Sandia National Laboratories Albuquerque, New Mexico August 2011

DOE/Sandia Responses to NMED's “Notice of Disapproval: Mixed Waste Landfill Corrective Measures Implementation Report, January 2010”

Comments and Responses for the Mixed Waste Landfill Corrective Measures Implementation Report

Figure 2-5
Schematic MWL-MW4 PVC Well Casing and Protective Surface Casing Extension Diagram

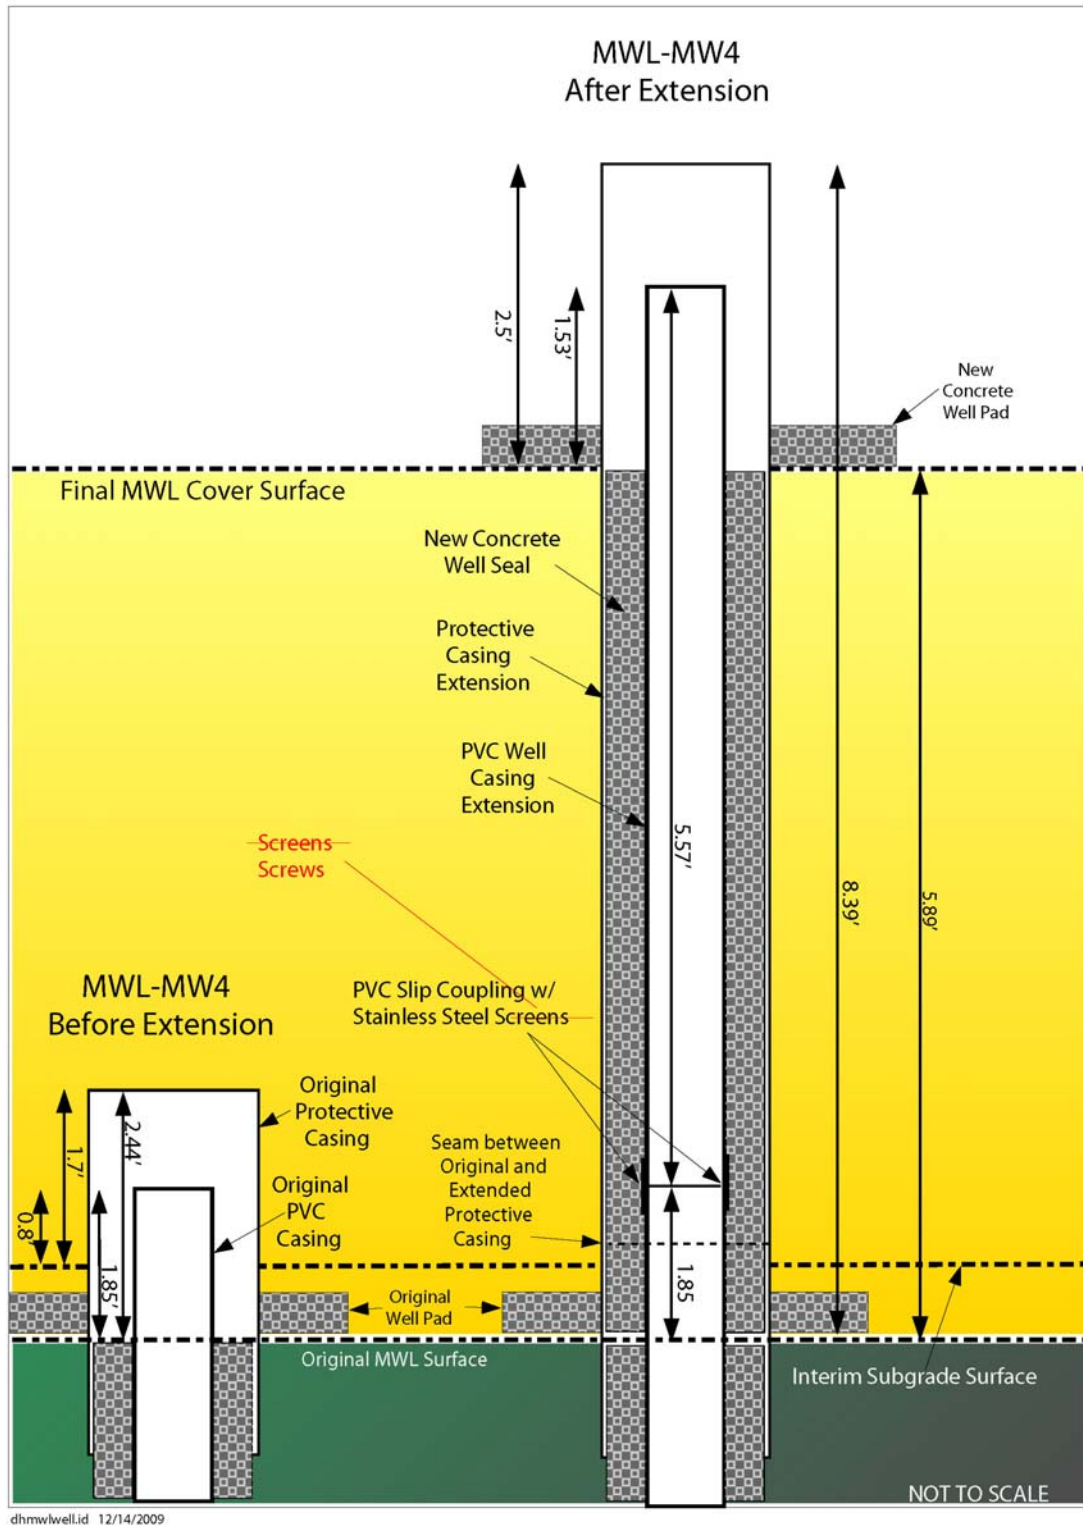
CQA Report, Attachment 8, Figure 2-5, center of figure: "PVC Slip Coupling w/ Stainless Steel Screens" should read "PVC Slip Coupling w/Stainless Steel Screws".

Also in Attachment 8, Section 3, first bullet provides justification of the "double anchored" well resulting from not demolishing the original well pad. The Permittees should carefully monitor and observe the upper 10 feet of the interior casing during future sample events to monitor whether this arrangement causes damage to the well casing from potential settlement of underlying waste.

Response: The error in Figure 2-5 of Attachment 8 in the CQA Report (Appendix A of the CMI Report, Volume 2), has been corrected. The associated revision to the CQA Report is tracked in Table 1 and documented in redline-strikeout format in Attachment 1. Attachment 2 of this comment response document provides the replacement page, and the revised figure is incorporated into the electronic version of the CMI Report (January 2010, Revision 1) provided on both CDs.

In addition, DOE/Sandia will inspect the upper 10 feet of the interior casing during future sampling events to monitor whether this arrangement causes damage to the well casing from potential settlement of underlying waste.
